DATE: December 23, 2024

ADDENDUM NO. 3

PROJECT NO. DGS C-0503-0027 PHASE 001
PROJECT TITLE - Danville State Hospital - Replace Steam Generation Equipment
PROFESSIONAL:

DRAWN BY Author	DATE 10-14-2024	SHEET No.
CHECKED BY Checker	SCALE As indicated	A-1

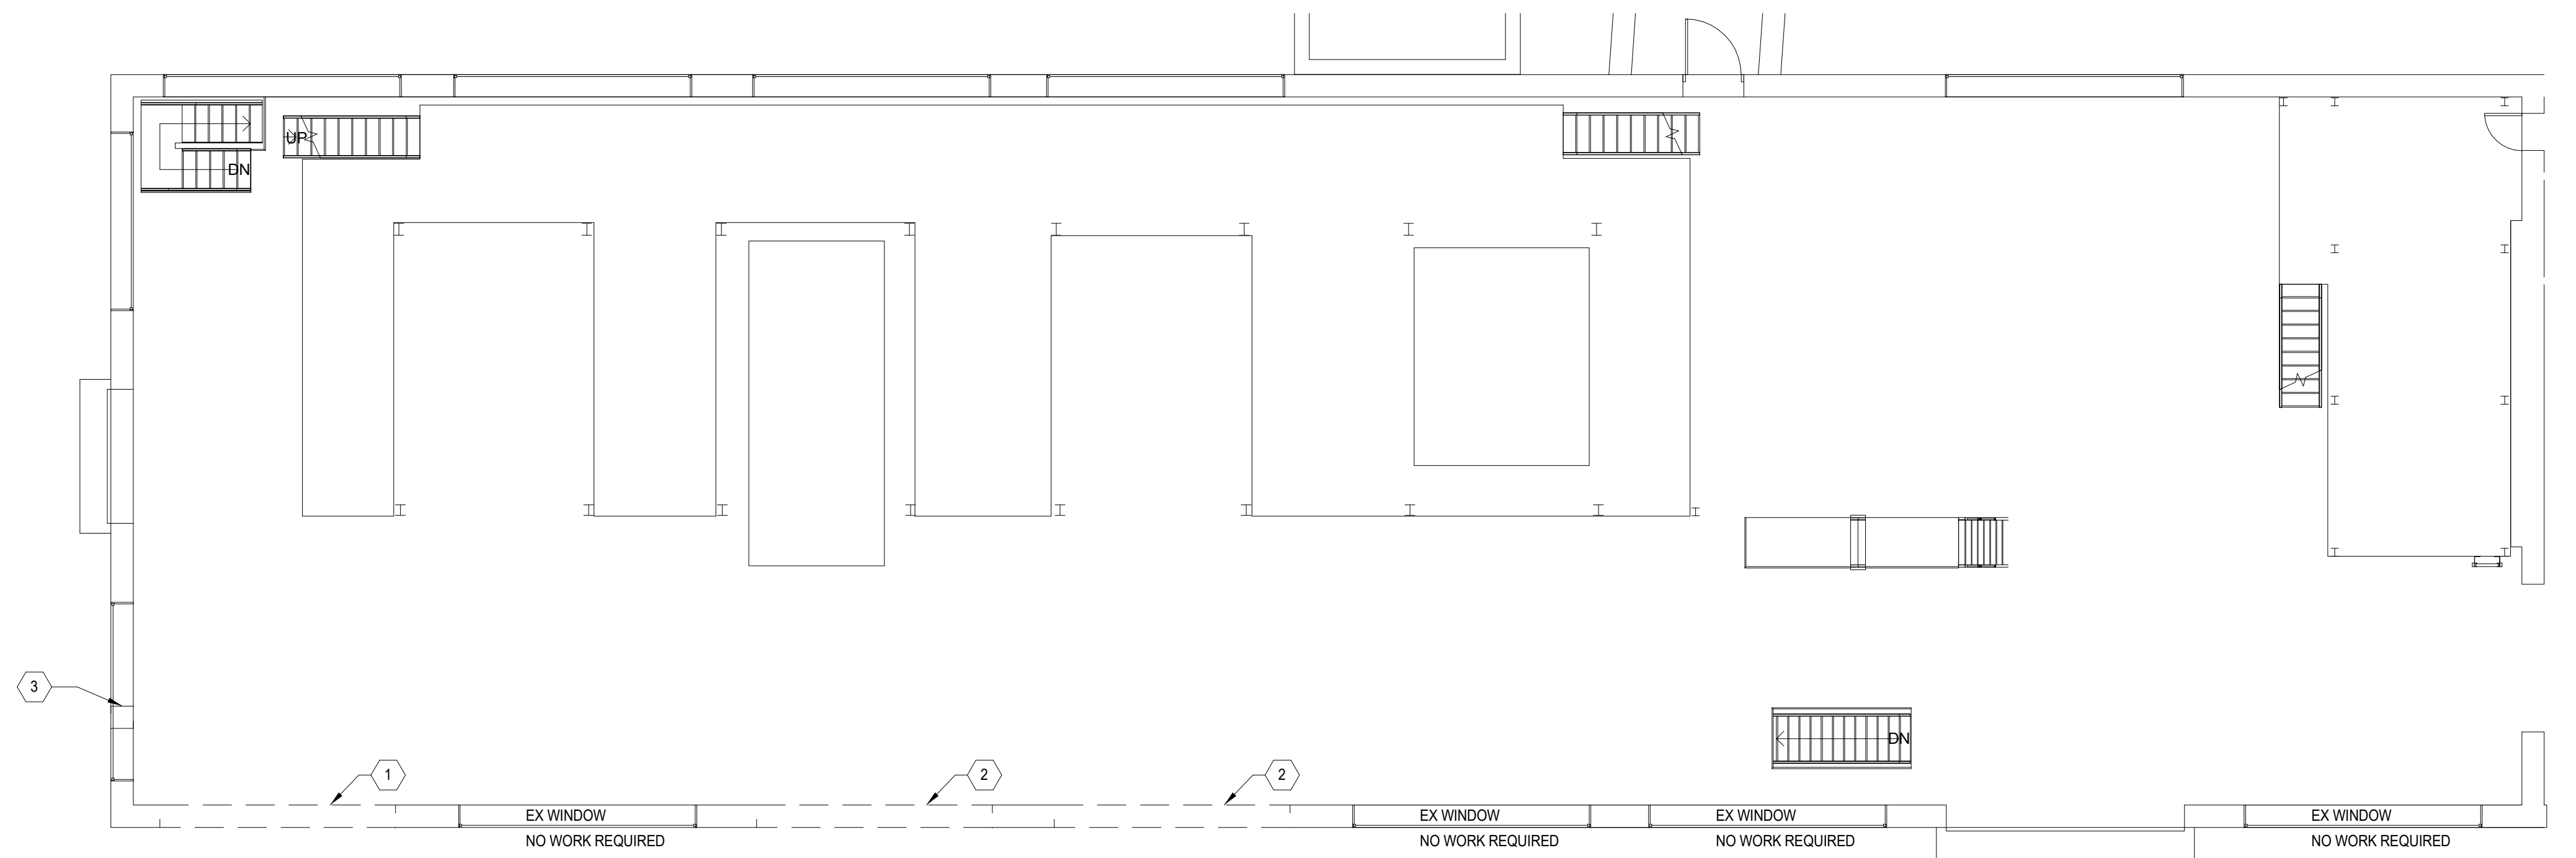
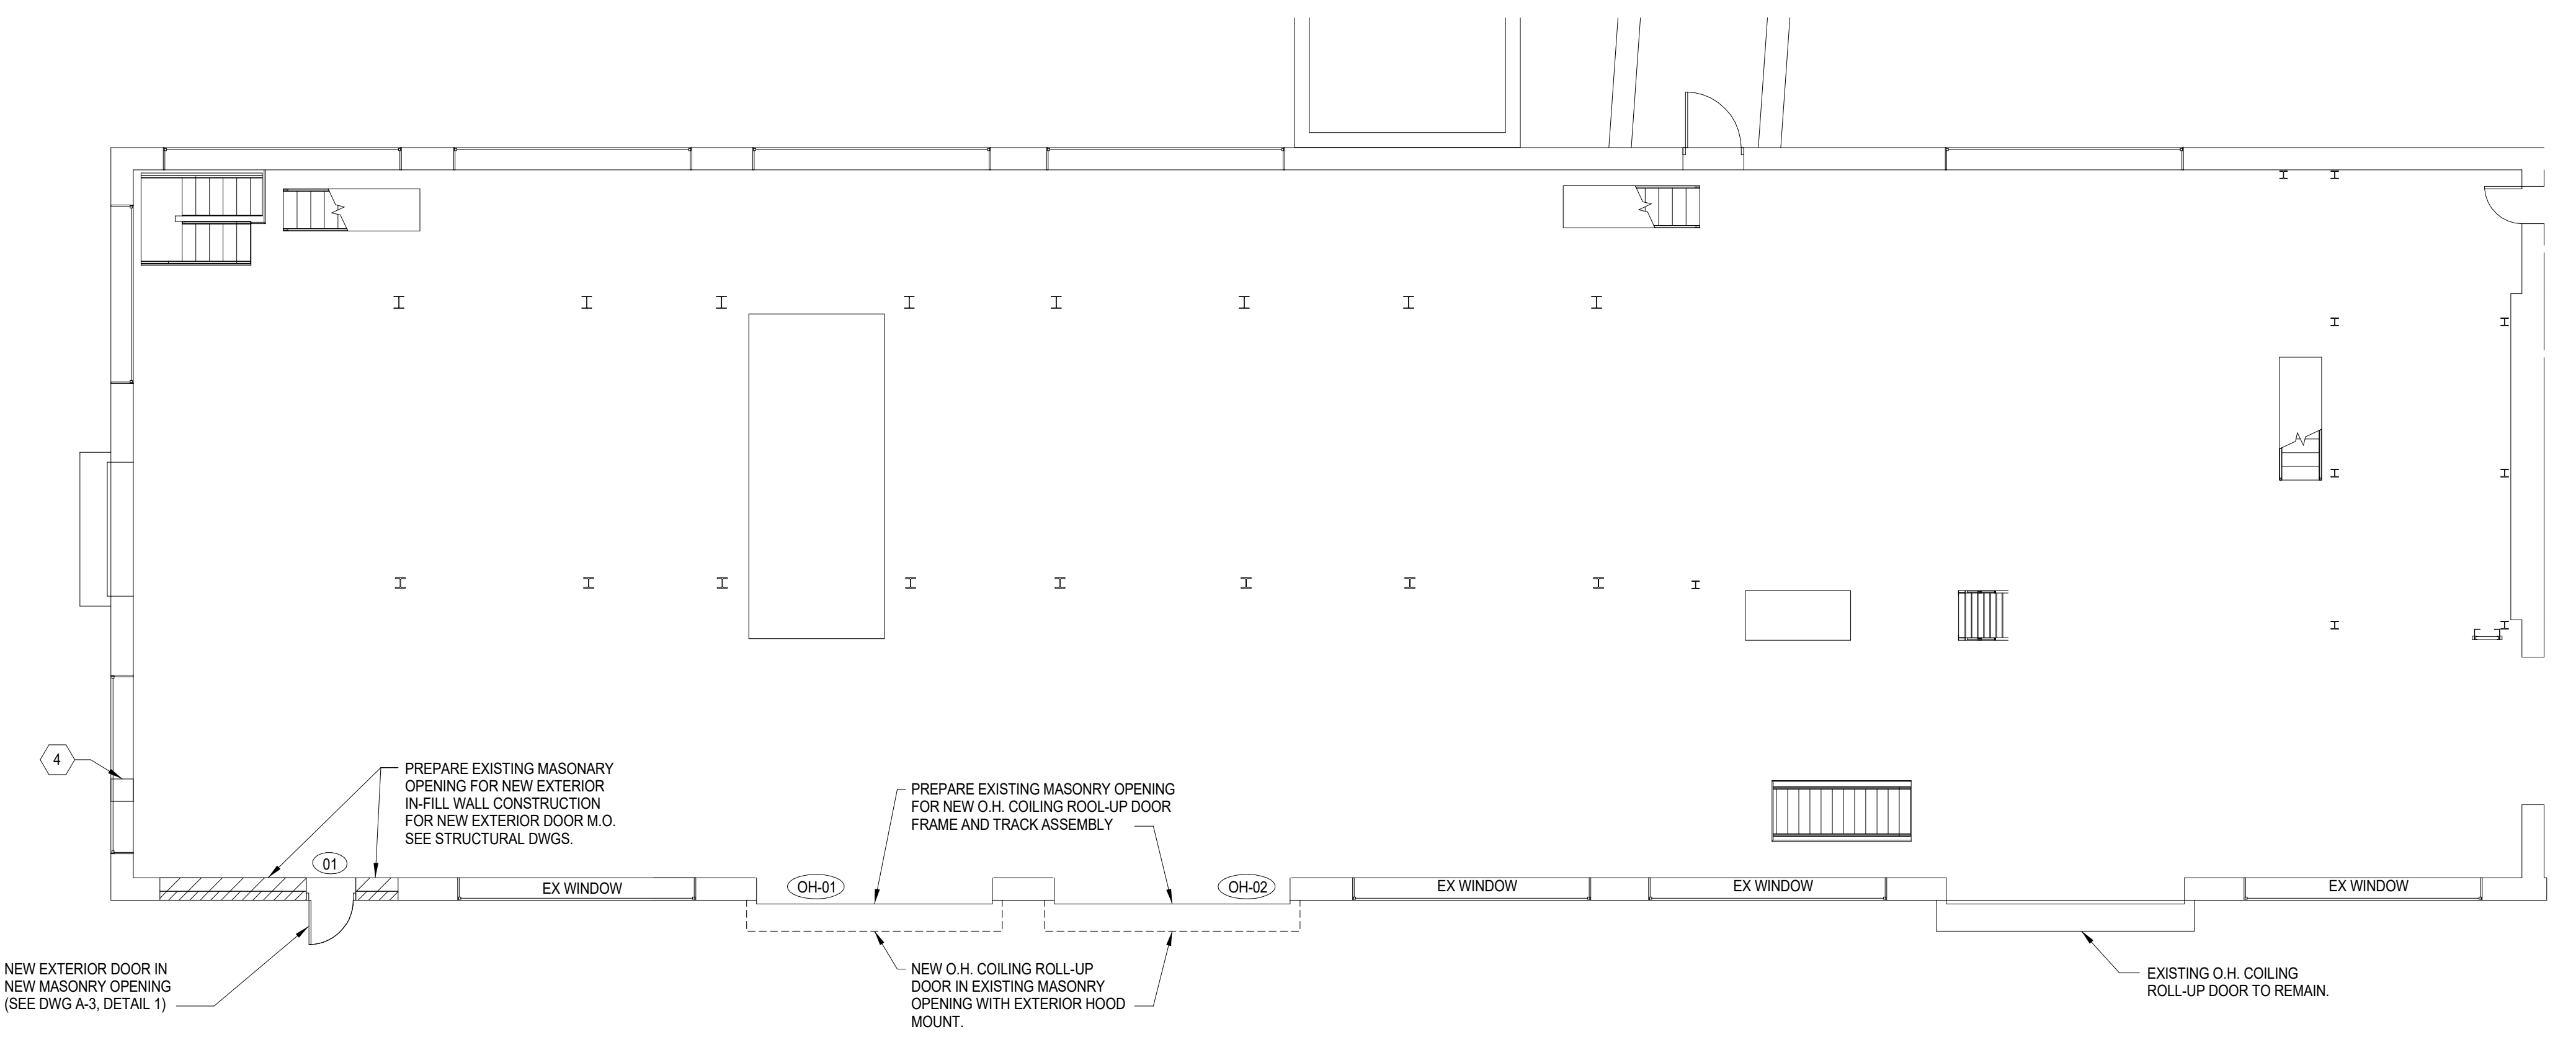
The facility is performing the demolition work to remove two sections of approx. 144 square feet of steel frame window for new overhead coiling door / frame assembly and one section of approx. 144 square feet of steel frame window for new man door / frame assembly as noted on drawing A-1 & 2. This portion of work is removed from the scope of the project. Drawings A-1 & 2 have been revised to indicate that this work is being performed by the facility. Specification Section 010100 – Summary of Work and 010300 – Base Bid Descriptions have been revised to remove wall demolitions.

The facility is performing the abatement of the windows being removed for the two new overhead coiling doors, man door, and existing piping insulation where new pipe is to connect to the existing piping mains. This portion of work is removed from the scope of the project. Drawings A-1 & 2 have been revised to indicate that this work is being performed by the facility.

- ① CLIENT AGENCY IS TO REMOVE EXISTING APPROX. 144 SQFT STEEL FRAME WINDOW UNIT COMPLETE. CLIENT AGENCY IS TO REMOVE PORTION OF EXISTING MASONRY WALL FOR NEW MAN DOOR / FRAME ASSEMBLY.
- ② CLIENT AGENCY IS TO REMOVE EXISTING APPROX. 144 SQFT STEEL FRAME WINDOW UNIT COMPLETE. CLIENT AGENCY IS TO REMOVE PORTION OF EXISTING MASONRY WALL FROM WINDOW SILL TO EXISTING FLOOR SLAB FOR NEW OVERHEAD COILING DOOR / FRAME ASSEMBLY.
- ③ REMOVE EXISTING APPROX. 10 SQFT SECTION OF MASONRY GLAZING FROM EXISTING STEEL FRAMED WINDOW AT THE UPPER LEVEL WINDOW UNIT FOR NEW 18" Ø FLUE PIPE.
- ④ PREPARE EXISTING STEEL FRAME WINDOW OPENING AT THE UPPER LEVEL WINDOW FOR NEW FLUE PENETRATION PANEL. FURNISH AND INSTALL NEW METAL FRAME INSERT ASSEMBLY FOR NEW FLUE PANEL.

DEMOLITION NOTE
 ① CONTRACTOR RESPONSIBLE FOR ASBESTOS ABATEMENT AND FOR PROPER REMOVAL OF EXISTING STEEL FRAME EXTERIOR WINDOW UNIT FOR NUMBERED NOTE ①. REFERENCE SPEC SECTION 028000 FOR ADDITIONAL INFORMATION.
